DEVIATION REQUEST AND DECISION FORM

Project Name : **BENT GRASS EAST COMMERCIAL FILING NO. 3**
 Schedule No.(s) : 53011-01-060
 Legal Description : Tract BB, Bent Grass East Commercial Filing No. 2B

BENT GRASS EAST COMMERCIAL FILING NO. 3		PEDESTRIAN ACCESS EXHIBIT	
DESIGNED BY	PRA	SCALE	DATE 4-5-21
DRAWN BY	PRA	(H) 1" = 30'	SHEET 1 OF 1
CHECKED BY		(V) 1" = N/A	JOB NO. 2177.64

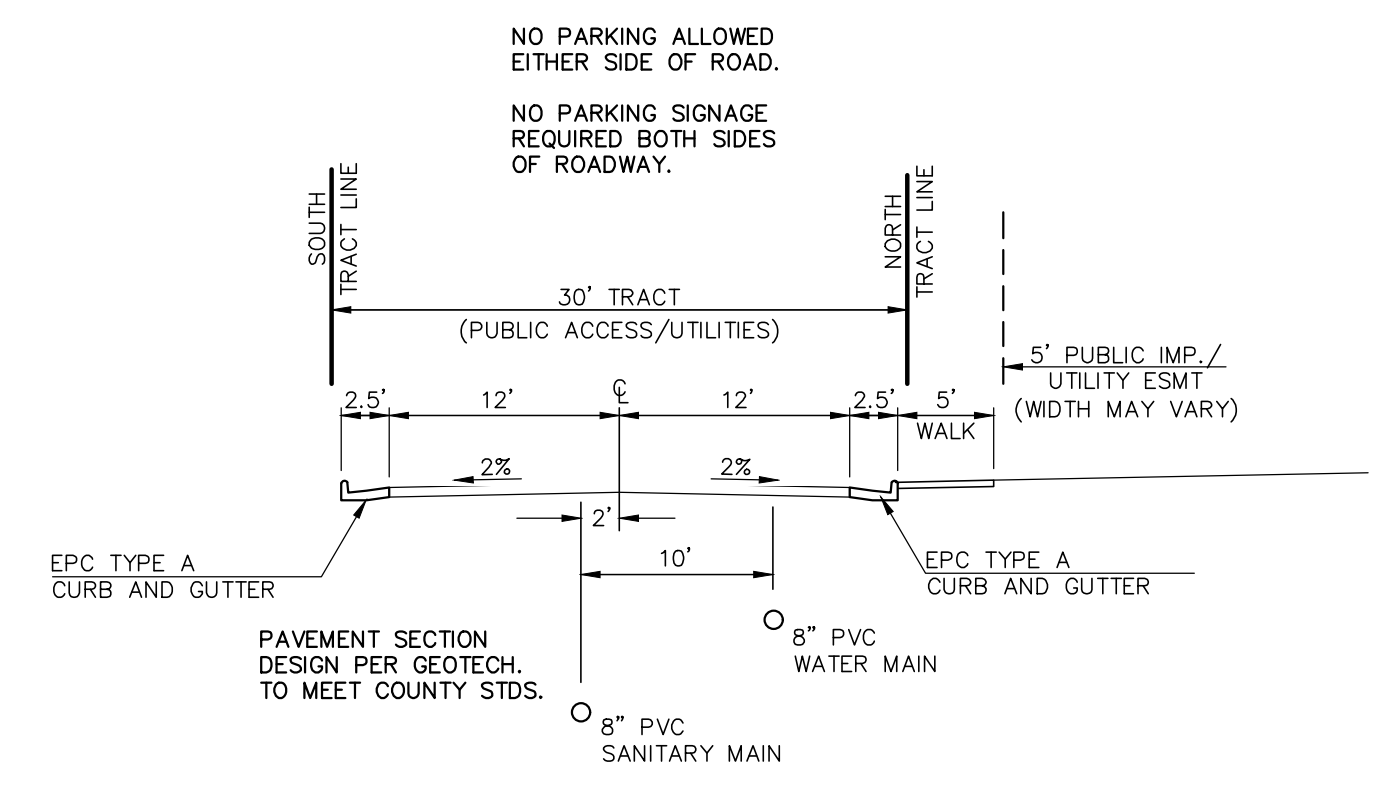
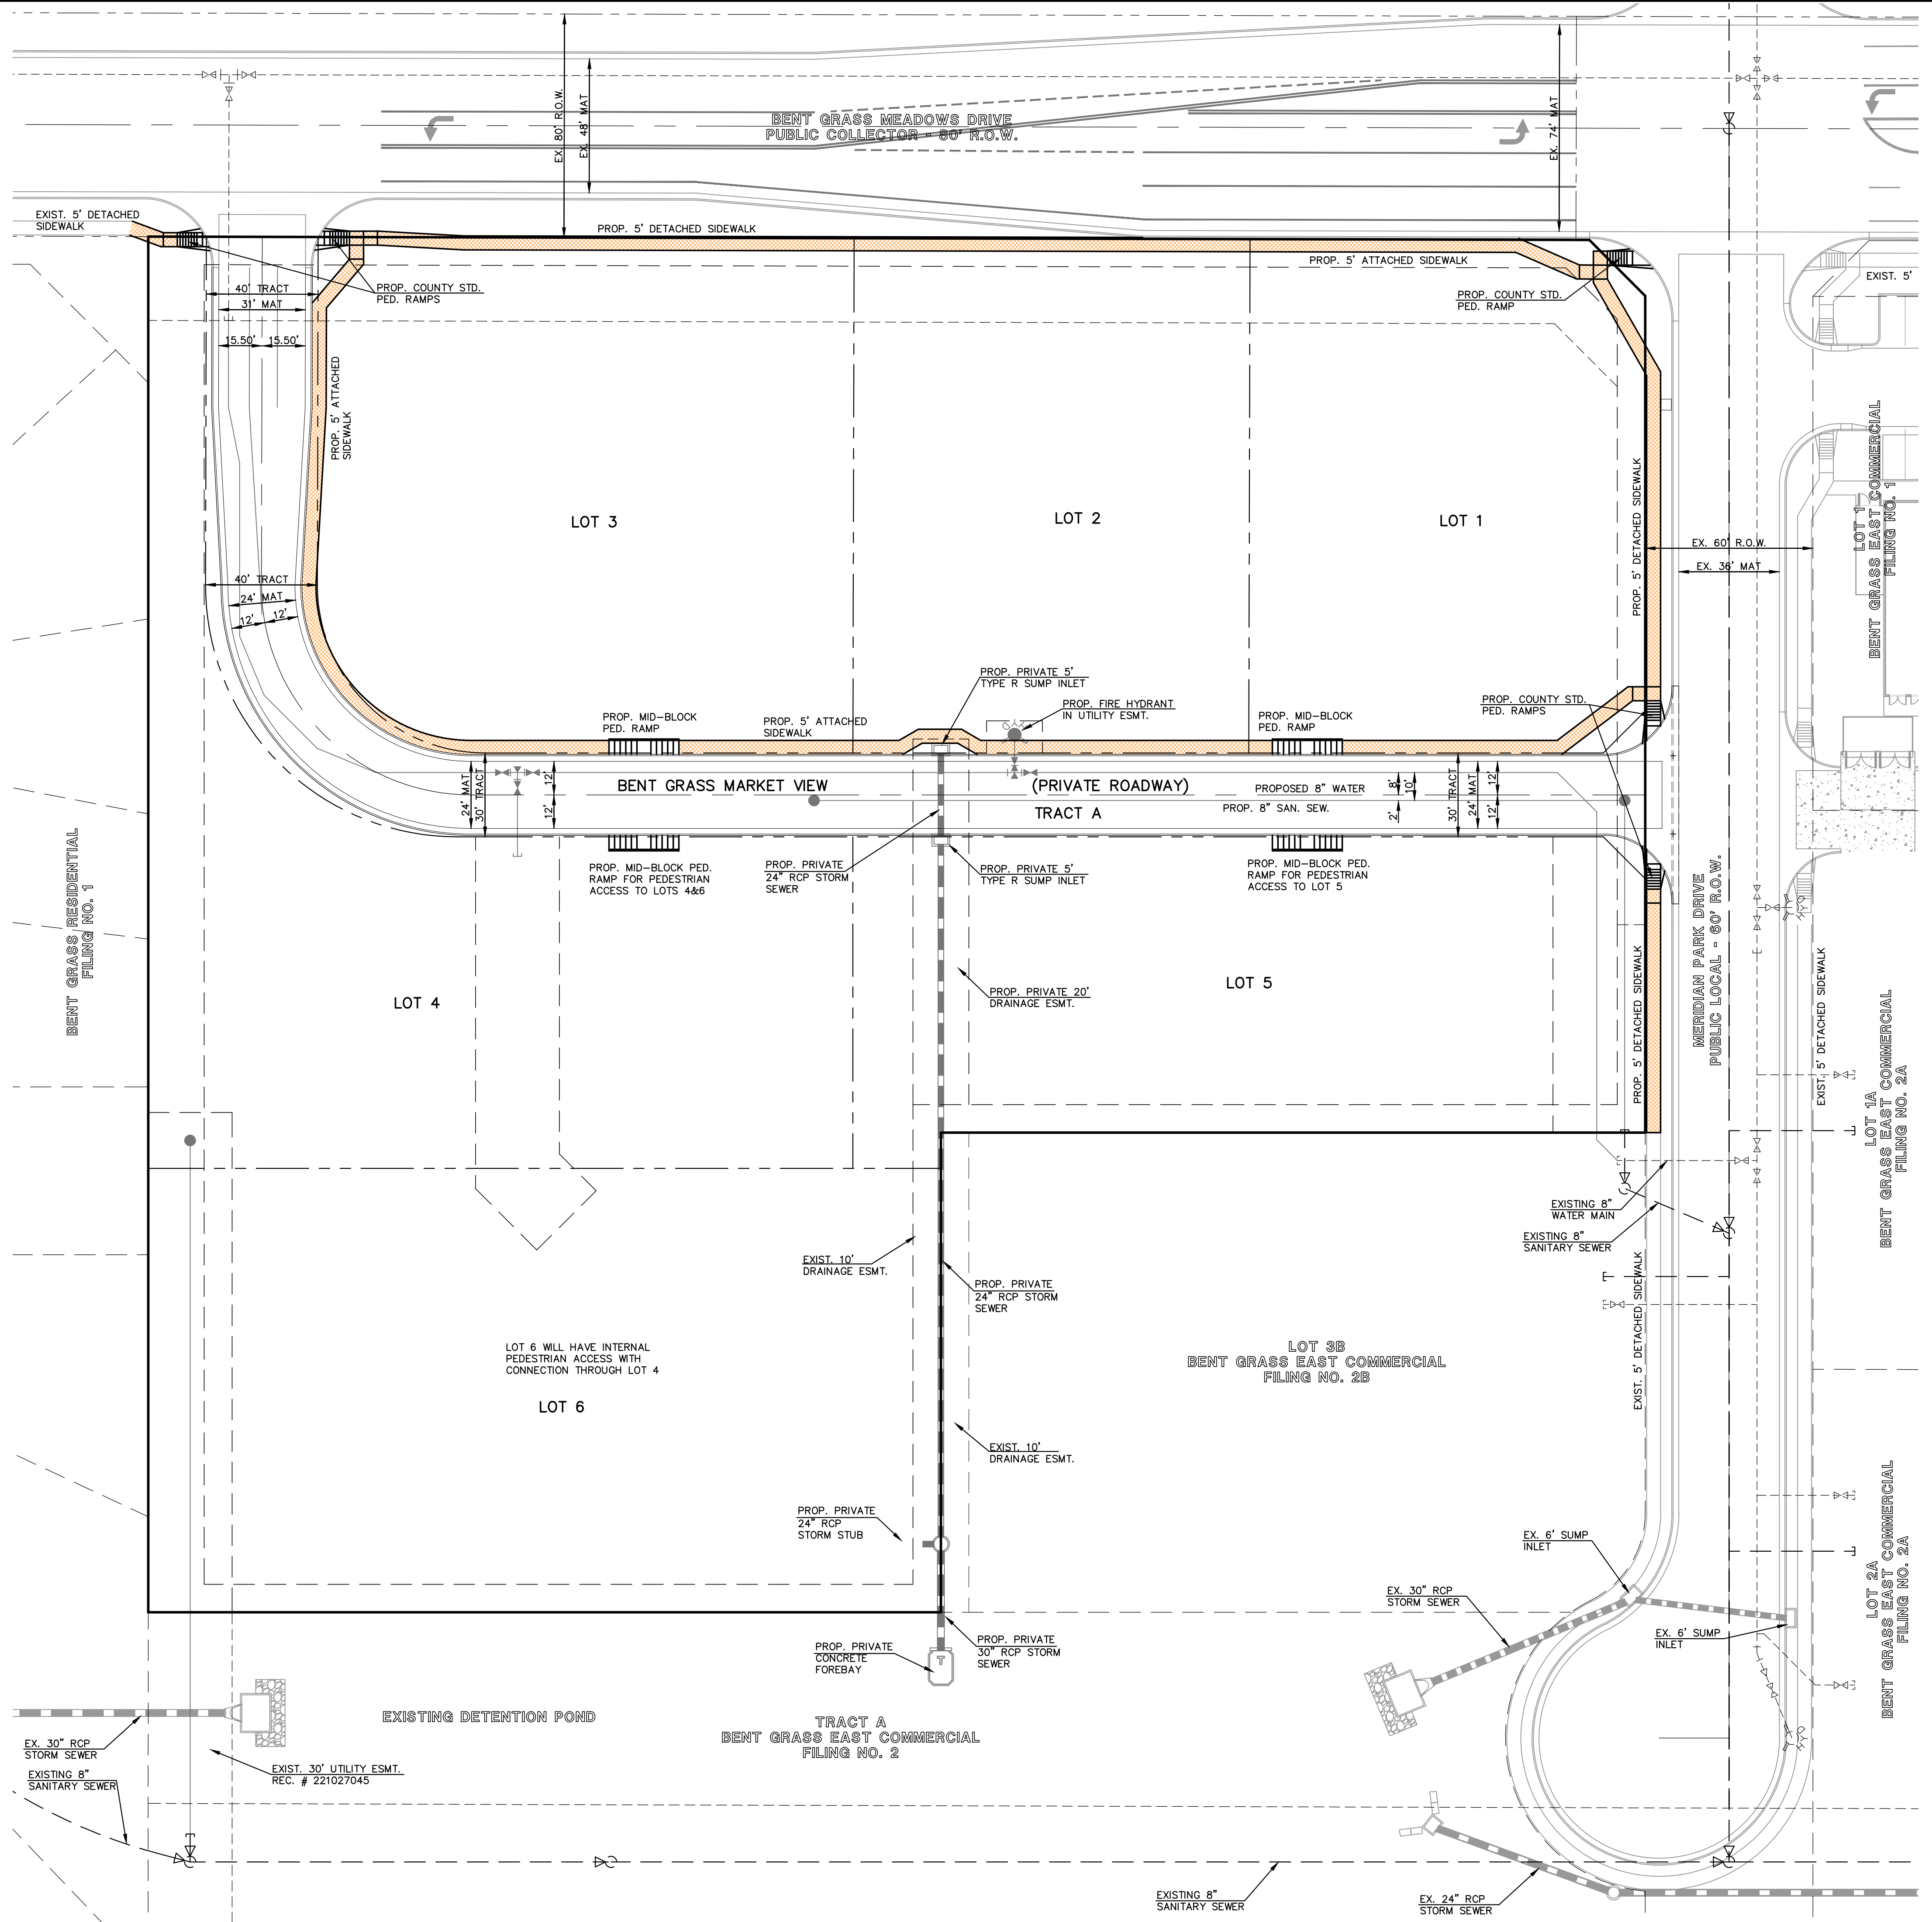
Although comments have been provided, the justification provided within this deviation is not sufficient at this time for the County to support a 24' cross section.

Is the intent for the owners of lot 4 and 5 to construct the sidewalk for access between the two lots and their businesses? Please address.

The radius proposed does not appear sufficient as the design vehicle encroaches onto opposing traffic. Please revise accordingly.

Adequate justification for the 24' width proposed has not been provided. The 24' width is not sufficient for the traffic generated. Based on the proposed uses, turn lanes may be required along this roadway and the proposed width does not provide sufficient space for future turn lanes. The ECM does provide adequate road sections for commercial developments such as this. The County can support a private road however it must meet standards for this volume of traffic.
